**SUBJECT: SURRY POWER STATION, UNITS 1 AND 2 – ISSUANCE OF AMENDMENTS
FOR GENERIC LETTER 2008-01 (GAS ACCUMULATION) (CAC NOS. MF5600
AND MF5601)**

SAFETY EVALUATION BY THE OFFICE OF NUCLEAR REACTOR REGULATION

SURRY POWER STATION, UNITS 1 AND 2

Figure 1. Surry SI System

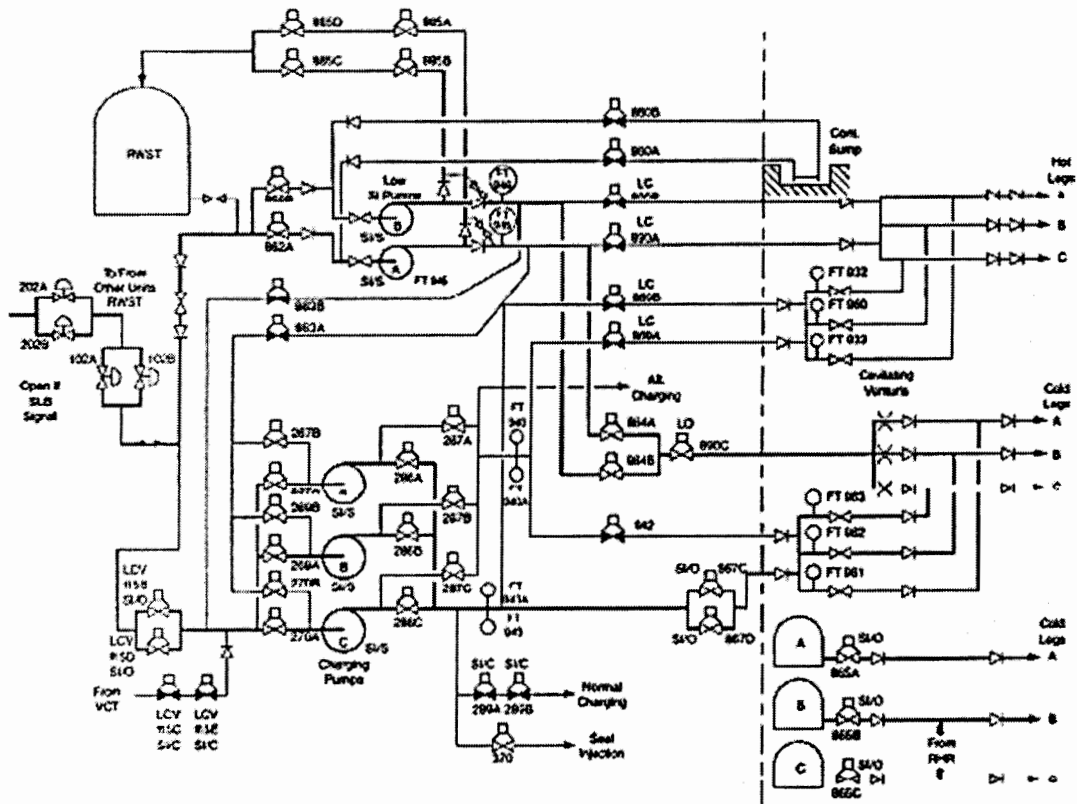
The SI system configuration from letter dated January 25, 2016 (ADAMS Accession No. ML16029A078) is shown in figure 1.

As shown in the bottom right corner of Figure 1, SI system lines are independently connected to the RCS. Each RCS loop has a separate accumulator line connection that is independent of the HHSI and LHSI RCS loop connections. RCS pressure is significantly greater than that of the accumulators, thus, the accumulators cannot cause back-leakage into the SI system.

During normal operation, the charging and HHSI lines are pressurized to above RCS pressure and consequently RCS leakage into these lines cannot occur. This is not the case with the LHSI lines and back-leakage is potentially possible. Surry performs quarterly UT of the LHSI discharge lines. The proposed TS surveillance primarily addresses this piping.

Figure 2. CS System Suction Piping

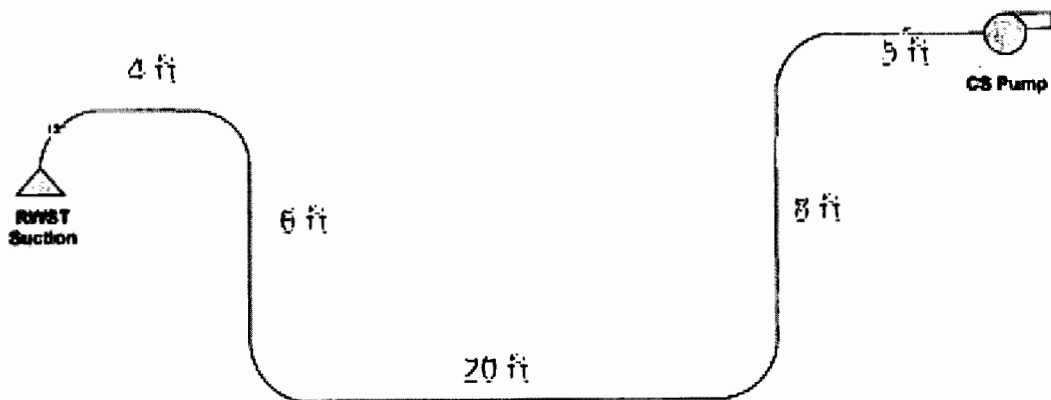
The CS suction piping from the RWST is illustrated in Figure 2.

Dominion concluded that the combination of N_{FR} and turbulence in the 4 foot pipe at the lowest flow rate would be sufficient to sweep gas out of the system. Based on the evaluation of Dominion's review, the NRC staff concludes this is acceptable.

Figure 3. CS Connections to RWST

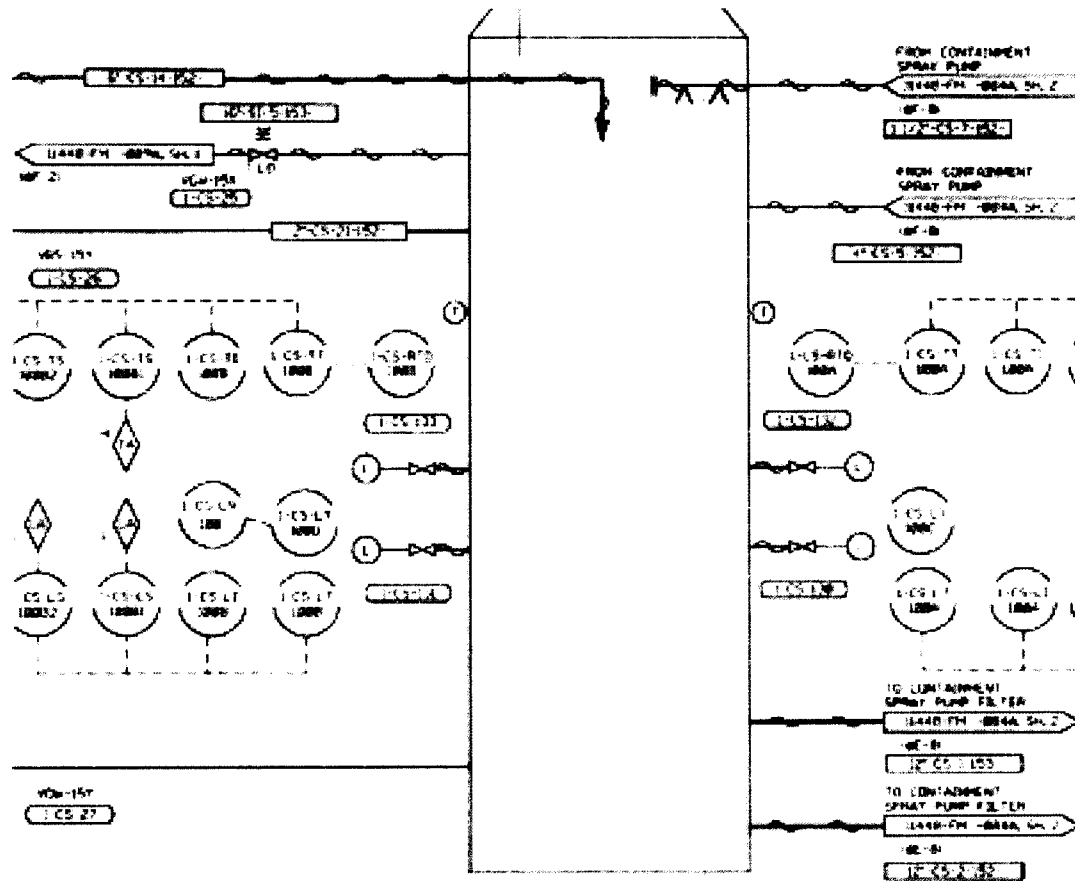
As shown in Figure 3, each train has a separate pipe from the RWST

Dominion stated that there are no identified gas intrusion mechanisms for the CS system. Since the CS piping is free of potential gas voids, a routine surveillance to preclude gas accumulation by verifying the CS piping is sufficiently filled with water is unnecessary.

Based on the above evaluation and the NRC staff's review of the information provided by Dominion in a response to a request for additional information, the NRC staff concludes that this is acceptable to not conduct periodic surveillances of the CS system.
